Access Compliance Report

Public Rights-of-Way

(Curb Ramps)

Intersection ID: 47684	Main Street: NEWFIELD_ST	Cross Street: LEWISBURG_ST	Location:	N
ADA ID: DA1FA0BF5912	Ramp Type: Perp	Initial Pass/Fail: Fail	Overall Compliance: No	Severity Score: 8.75
Codes/Mitigation Info/Possible Solution		Field Measurements/Component Compliance

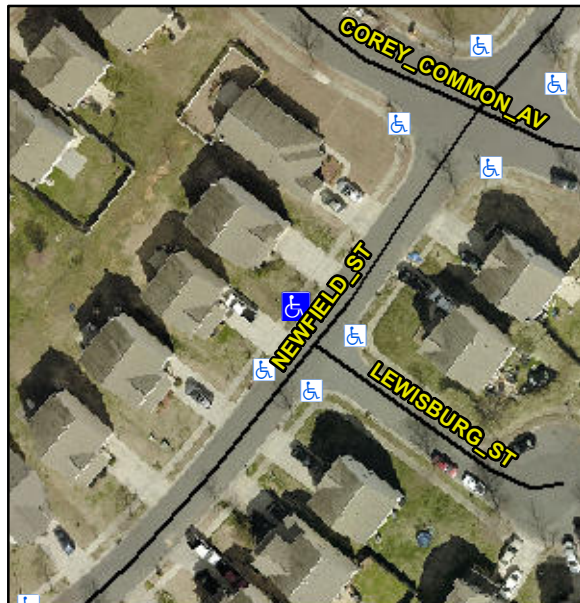
Not Found, R304.5.1

Compliance	Description	Data	Compliance	Description	Data
N/A	Ramp Length (in)	47.0	Yes	Ramp Slope (%)	5.6
No	Ramp Width (in)	47.0	Yes	Ramp XSlope (%)	0.9
N/A	Flare Type LT	N/A	N/A	Flare Type RT	N/A
N/A	Flare Slope LT (%)	N/A	N/A	Flare Slope RT (%)	N/A
N/A	Flare Traversable LT?	N/A	N/A	Flare Traversable RT?	N/A
N/A	Landing Length (in)	N/A	N/A	DWS Provided?	N/A
N/A	Landing Width (in)	N/A	N/A	DWS Contrast?	N/A
N/A	Landing Slope (%)	N/A	N/A	DWS Length (in)	N/A
N/A	Landing X Slope (%)	N/A	N/A	DWS Full Width?	N/A
N/A	Landing Curb? (Y/N)	N/A	N/A	DWS Offset (in)	N/A
N/A	Shared Landing?	N/A			
N/A	Gutter Ponding?	N/A	N/A	Gutter Slope (%)	N/A
N/A	Gutter Lip Ht (in)	N/A	N/A	Gutter X Slope (%)	N/A
N/A	Painted X Walk1?	No	N/A	Painted X Walk2?	N/A
	X Walk 1 Direction	To SE		X Walk 2 Direction	N/A
N/A	X Walk 1 Width (in)	N/A	N/A	X Walk 2 Width (in)	N/A
	X Walk 1 Slope (%)	2.1		X Walk 2 Slope (%)	N/A
	X Walk 1 X Slope (%)	0.6		X Walk 2 X Slope (%)	N/A

Remove & Replace Entire Ramp.
